BWRVIP-234NP-A: BWR Vessel and Internals Project

Thermal Aging and Neutron Embrittlement of Cast Austenitic Stainless
Steels for BWR Internals

NRC SAFETY EVALUATION

June 22, 2016

Figure A1. Plot of predicted lower-bound J @ 2.5 mm (BWRVIP-100 and NRC staff proposed) vs. neutron fluence. Arrow reflects shift of BWRVIP-100 curve to the left, represents assumed contribution to lower-bound J @ 2.5 mm due to IE.

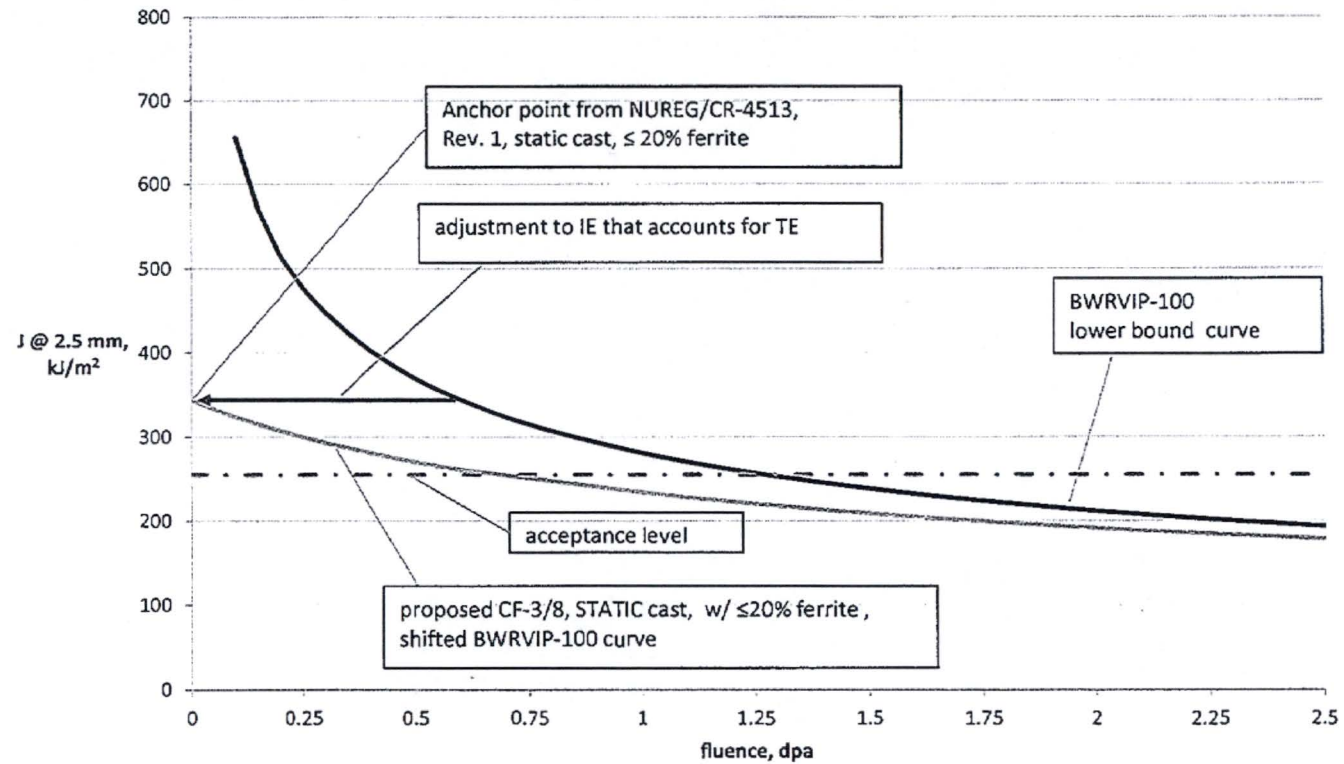
5	Second page of Appendix A, Figure A1	Accuracy	The "< 20 % ferrite" values in Figure A1 need to be changed to "≤ 20% ferrite" to be consistent with Table A1.	Agreed
6	Headers throughout	Clarification	As the SE does not contain any EPRI proprietary information, "Proprietary Information" can be removed from the headers.	Agreed

Figure 2-1
Effect of aging temperature on the fracture toughness of sample CF-8M heats

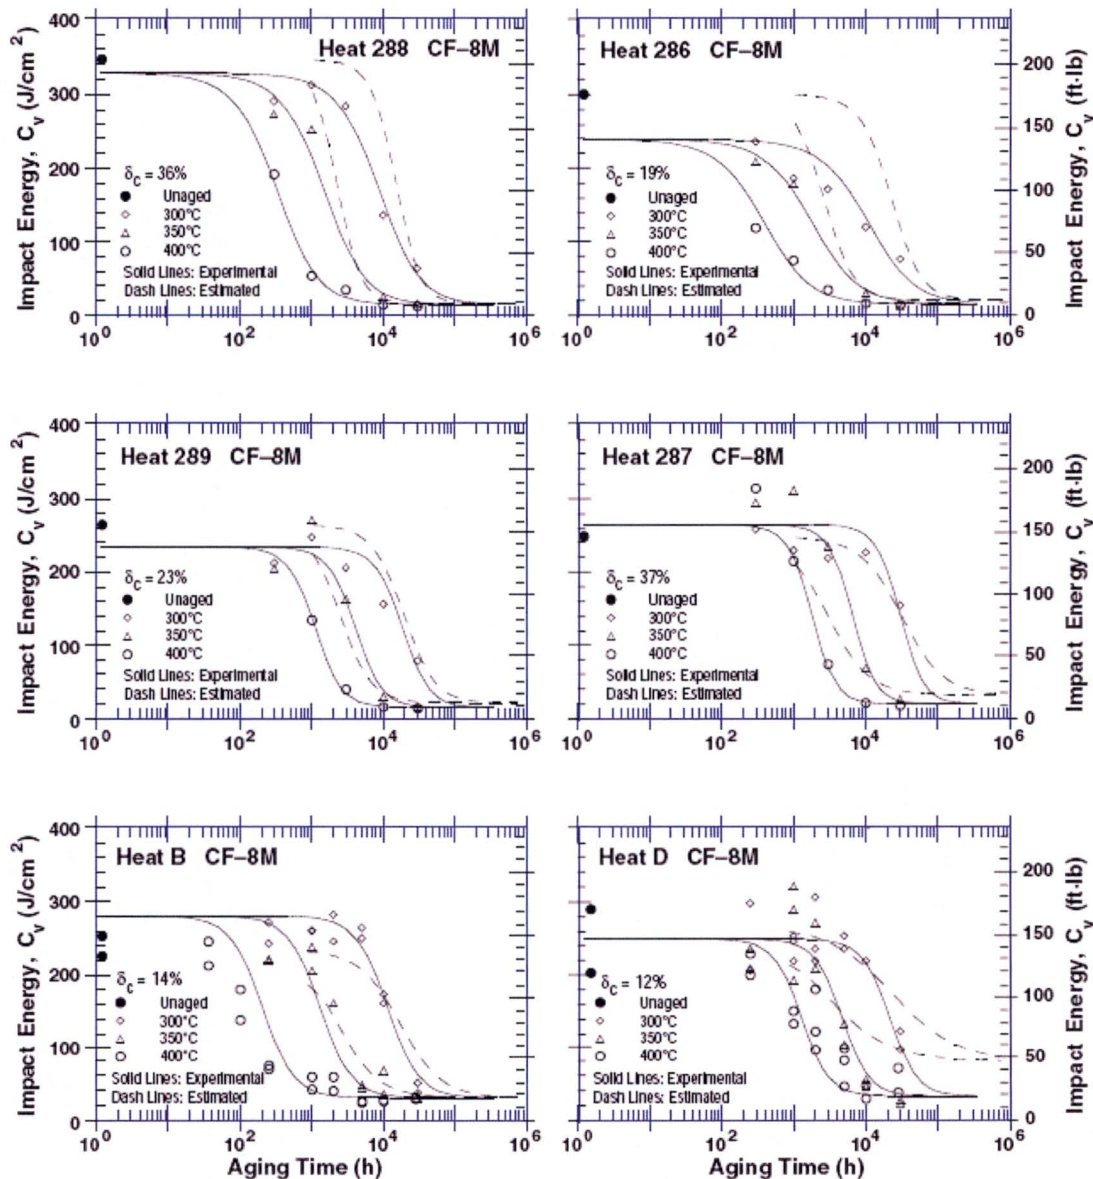
For Figure 2-1, the absorbed energy saturation values for the CF-8M castings are between 10 and 20 ft-lbs. The saturation is reached in about 10^5 hours at the temperature of 300° C. These values are independent of the delta ferrite content. Is this result consistent with other alloys like CF-8 and CF-3?

For Figure 2-1, the absorbed energy saturation values for the CF-8M castings are between 10 and 20 ft-lbs. The saturation is reached in about 10^5 hours at a temperature of 300°C. These values are independent of the delta ferrite content. Is this result consistent with other alloys like CF-8 and CF-3?

The purpose of Figure 2-1 was to show that CF-8M is very susceptible to thermal embrittlement (TE). In fact it is the least resistant of the CASS materials to TE. This is consistent with results reported in NUREG/CR-4513, Revision 1 (Reference 13 in BWRVIP-234) and Reference 5 of BWRVIP-234.

Reference 3 of BWRVIP-234 also provides an excellent review of the available data on the issue. Figure 2 below shows the effect of delta ferrite content, and aging temperature and time, and the impact energy at room temperature. This shows as ferrite content increases, the impact energy at long aging times decreases.

The saturation values of Charpy-impact energy for CF-3 and CF-8 materials used in BWRs are above CF-8M castings. Furthermore, Reference 5 of BWRVIP-234 states that “CF8M shows the greatest susceptibility to thermal aging of any of the other SA-351 grades considered in the screening criteria.”

There was no intent to apply the RT saturation values of impact energy shown in Figure 2-1 to an evaluation of BWR components. The important parameter used to evaluate component integrity is fracture toughness. For this evaluation, the lower bound value $J = 255 \text{ kJ/mm}^2$ has been used as approved by the NRC.

Figure 2-4
J-R curves for CF-8M CASS materials with various δ ferrite numbers

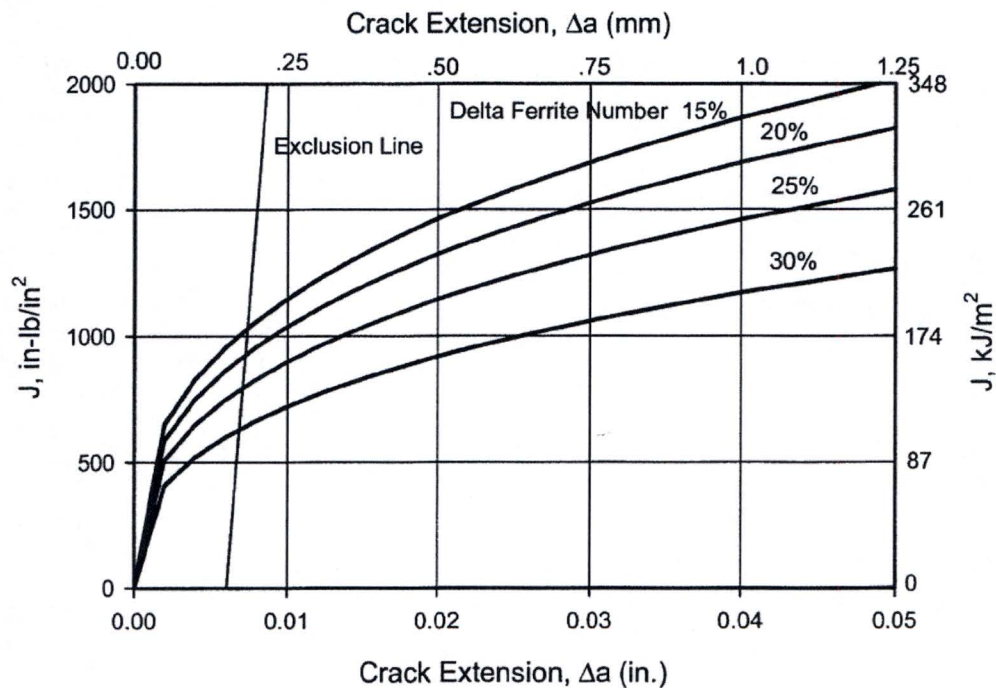
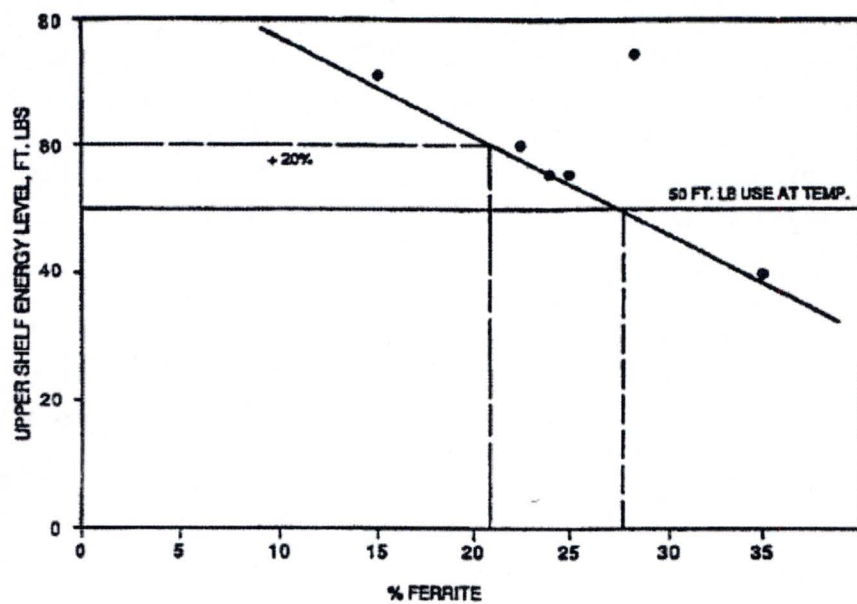
Figures 2-4 and 2-5 document the toughness as a function of delta ferrite content. The aging conditions for these test results should be included for our review. If these results represent the saturation of the TE effects, please discuss why these results are different from Figure 2-1 where the TE effects are not a function of delta ferrite content.

Discuss why room temperature Charpy absorbed energy is an appropriate way to quantify the extent of TE. The upper shelf energy (USE) that you show in Figure 2-5 could be a more valuable parameter because USE could be related directly to the service temperature, similar to what is done for ferritic reactor vessel properties.

Figures 2-4 and 2-5 document the toughness as a function of delta ferrite content. The aging conditions for these test results should be included for our review. If these results represent the saturation of the TE effects, please discuss why these results are different from Figure 2-1 where the TE effects are not a function of delta ferrite content.

Discuss why room temperature Charpy absorbed energy is an appropriate way to quantify the extent of TE. The upper shelf energy (USE) that you show in Fig. 2-5 could be a more valuable parameter because USE could be related directly to the service temperature, similar to what is done for ferritic reactor vessel properties.

Figure 2-4 was developed based on the equations contained in Section 3 of NUREG/CR-4513, Revision 1. Excerpts of EPRI report 1016236 (Reference 1 in BWRVIP-234) are contained in Attachment A to provide the staff with background regarding determination of the J-R curves.

Figure 2-5 is based on the following reference.

Figure 1. Plot of predicted toughness (J-integral value at 2.5 mm crack extension) from BWRVIP-100 and NUREG/CR-6960 as a function of neutron fluence. The predicted lower-bound toughness of CF-8 due to TE alone is shown for reference.

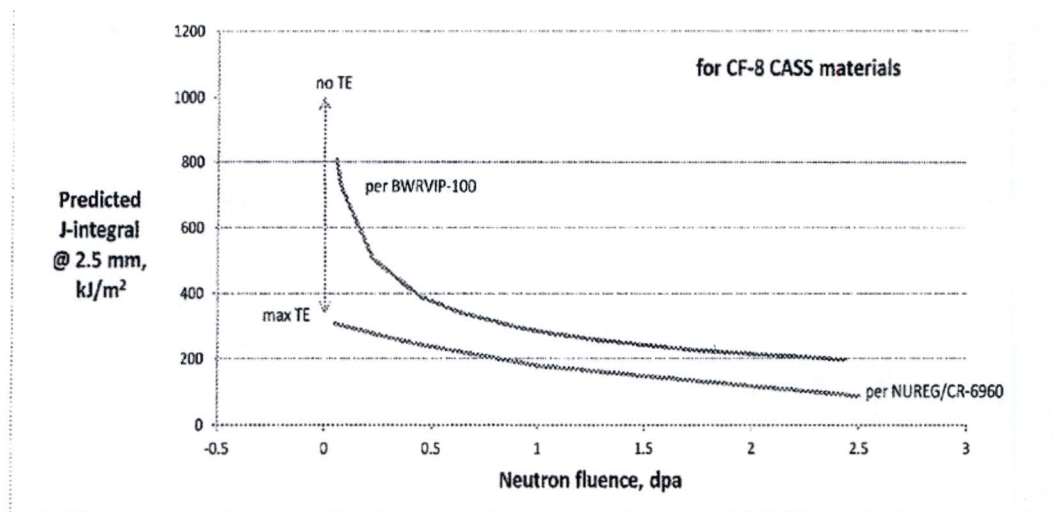
The NRC staff has reviewed the technical bases for the RAI responses and compared the methodology used in BWRVIP-234 to predict fracture toughness as a function of neutron exposure to a previously reported prediction from NUREG/CR-6960. The comparison is shown in Figure 1 along with the range of predicted J values at 2.5 mm crack extension for unirradiated CF-8 with no thermal embrittlement (TE) and maximum TE (no irradiation) for CF-8 with > 15 percent delta ferrite (Section 3.1.1 of NUREG/CR-4513, Rev. 1).

The NRC staff requests that the BWRVIP review all available data on fracture toughness of irradiated CASS materials, and the associated uncertainties, and to either revise its methodology to predict the lower-bound toughness of CASS materials at reactor operating temperatures after approximately 60 years of operation, or provide further justification that BWRVIP-100 is sufficiently conservative.

Figure 1. Plot of predicted toughness (J-integral value at 2.5 mm crack extension) from BWRVIP-100-A and NUREG/CR-6960 as a function of neutron fluence. The predicted lower-bound toughness of CF-8 due to TE alone is shown for reference.

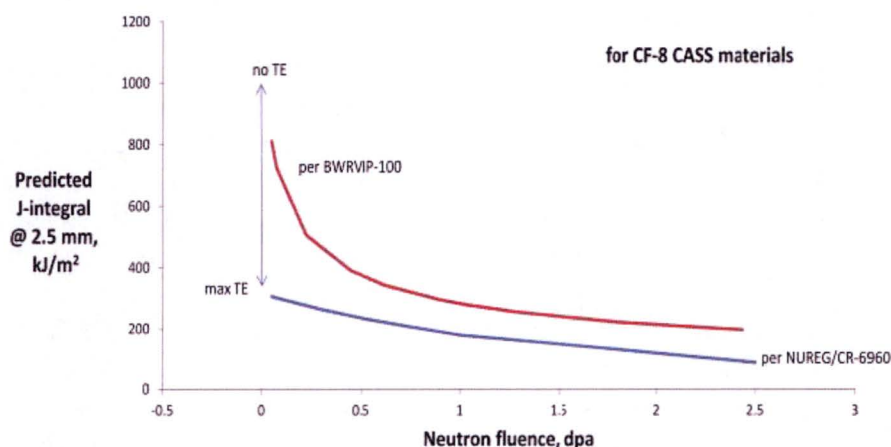
The NRC staff has reviewed the technical bases for the RAI responses and compared the methodology used in BWRVIP-234 to predict fracture toughness as a function of neutron exposure to a previously reported prediction from NUREG/CR-6960. The comparison is shown in Figure 1 along with the range of predicted J values at 2.5 mm crack extension for unirradiated CF-8 with no thermal embrittlement (TE) and maximum TE (no irradiation) for CF-8 with > 15 percent delta ferrite (Section 3.1.1 of NUREG/CR-4513, Rev. 1).

The NRC staff requests that the BWRVIP review all available data on fracture toughness of irradiated CASS materials, and the associated uncertainties, and to either revise its methodology to predict the lower-bound toughness of CASS materials at reactor operating temperatures after approximately 60 years of operation, or provide further justification that BWRVIP-100-A is sufficiently conservative.

The validity of the BWRVIP-234 methodology in this regard is confirmed by comparing the derived SAW and SMAW fracture toughness approximation with actual irradiated weld data, even though that actual weld data might have been obtained on material with a much higher fluence. The irradiated SAW and SMAW fracture toughness data can also be compared with the irradiated and thermally-aged fracture toughness data in Figure 2, which may help to understand why the effects of using sub-size CT test specimens may have significantly influenced the fracture toughness results.

The validity confirmation starts with Reference 2 which, in addition to the CASS data, also provides some very useful fracture toughness data on SAW and SMAW heat-affected zone material that has been subjected to accumulated neutron irradiation fluence of 1.44×10^{21} n/cm² (about 2 dpa). Figure 2, taken from Figure 72a in Reference 2, and Figure 3, taken from Figure 72b in Reference 2, are shown below for comparison. From these figures, the J-value at 2.5 mm (0.1 in.) is above 300 kJ/m² for the SMAW heat-affected zone, and slightly below 250 kJ/m² for the SAW heat-affected zone. For the wrought materials used as the starting point in BWRVIP-234, the J-R curve values at 2.5 mm of crack extension (see Table 4-3 of Reference 5) were 744 and 638 kJ/m², respectively. When these wrought values are adjusted downward by Z² factor, which is approximately 3, the agreement with the actual fracture toughness data is quite good, confirming the approach used in BWR-234.

Based on these findings, the industry recommends that the existing fracture toughness screening criterion for toughness of 255 kJ/m² at a crack extension of 2.5 mm (0.1 in.) remain in place.
